Subject: Data Response, Set 2D-3  
Hidden Hills Solar Electric Generating System (11-AFC-2)

# **Hidden Hills Solar Electric Generating System (HHSEGS)**

**Data Response, Set 2D-3  
(Response to Data Request 172)**

**Figure DR172 - 1**

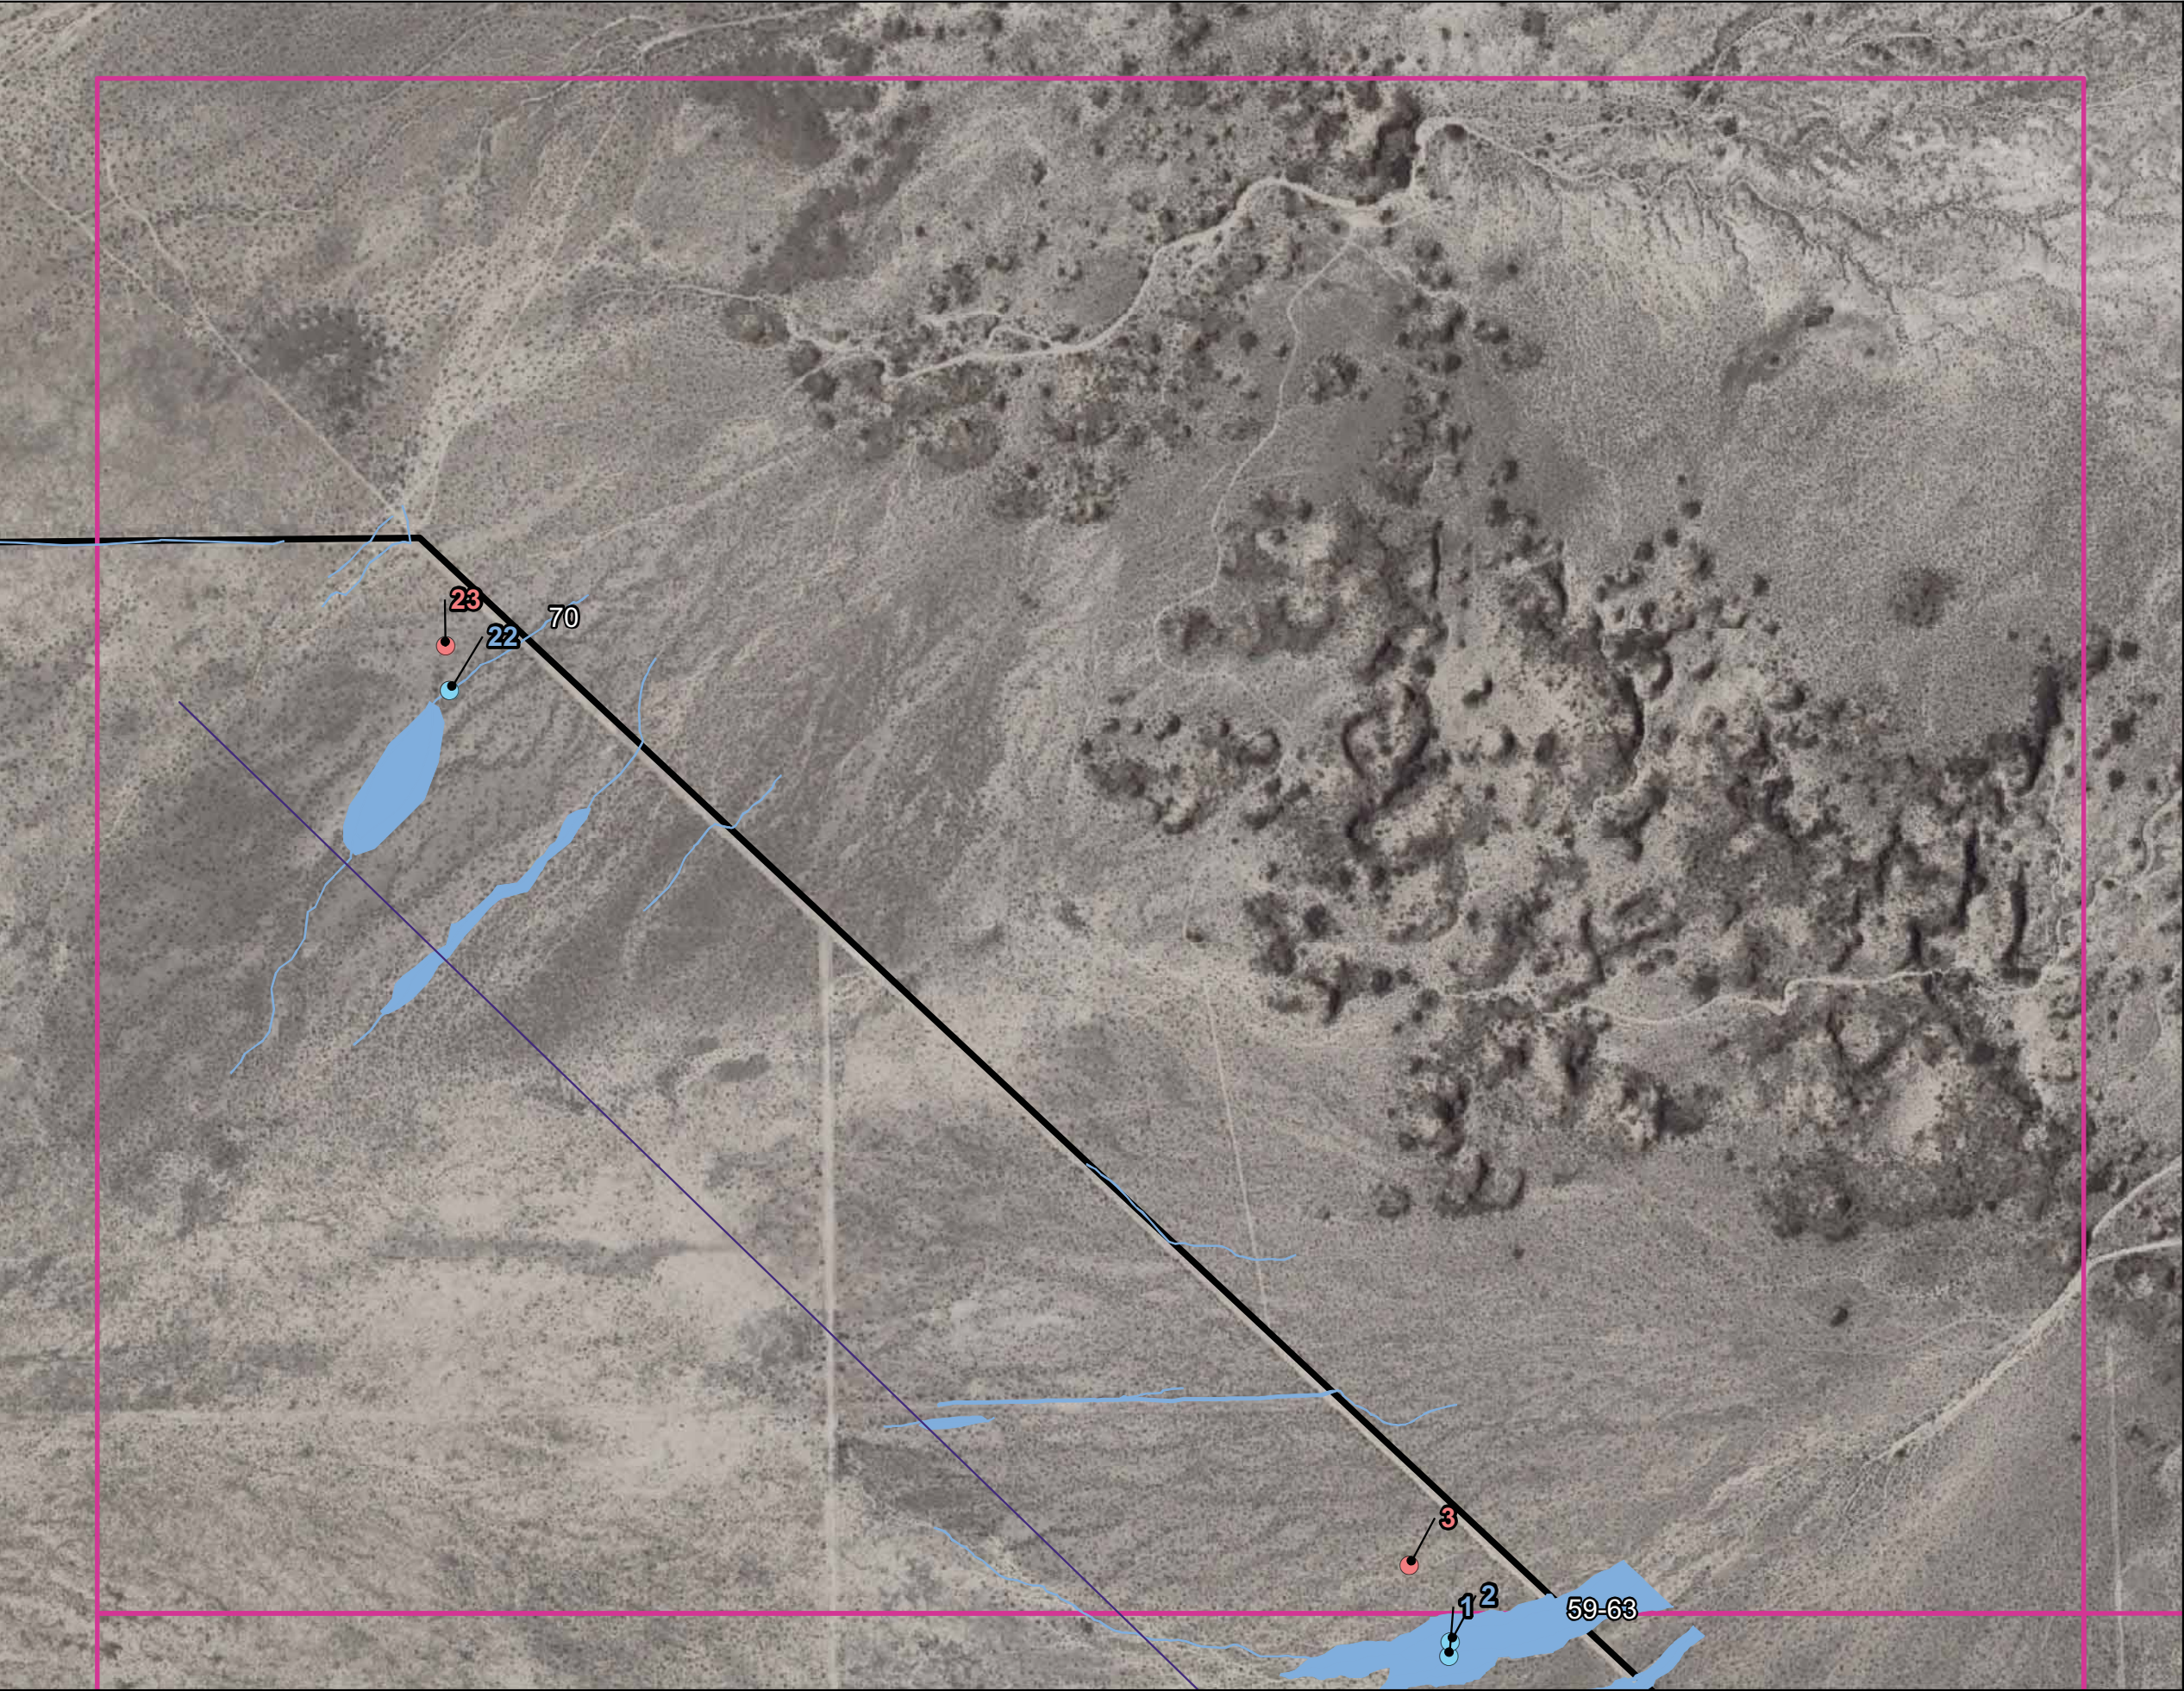
172. Please submit a detailed description of the vegetation that occurs along the ephemeral washes, and is distinct – at least in aerial photo signature – from the surrounding upland, including wash features that were not delineated. The description should include a list of dominant species in each layer. If the habitat does not differ in species composition, please indicate if it has a higher density or percent cover, or in some other way is distinct structurally. If the field notes are insufficient to fulfill this request, please collect this information during the spring 2012 botanical surveys and provide the description and at least one photo of the representative habitat (per habitat type, if there is more than one) in a separate report.

Additional information on the vegetation that occurs within the ephemeral drainages beyond the scope of the botanical survey was requested by the CEC. To address this data request, Mike Klinefelter and biologist Jon True conducted a site assessment of vegetation

that occurs along the ephemeral drainages and surrounding uplands (Figure DR172-1, all figures are at the end of this document). Fieldwork was conducted on April 9 and 10, 2012. GIS data of the delineated features shown in the URS delineation report were loaded onto a Trimble GeoXT handheld GPS receiver and were used to navigate to selected drainage locations in the field. A subset of the delineated drainages was surveyed throughout the site, and a number of other features were also examined. Vegetation data were collected and photos were taken at 11 drainages and corresponding upland areas. Along one of the larger drainages, data were collected in both the upper and lower reaches. The range of drainages was selected to provide a representative sample of conditions across the site and a sufficient data set with which to assess vegetation within the onsite drainages and nearby upland areas. Drainages of varying widths were assessed, including single channels as narrow as a few feet in width to areas with multiple channels that cumulatively extend to 80 feet in width.
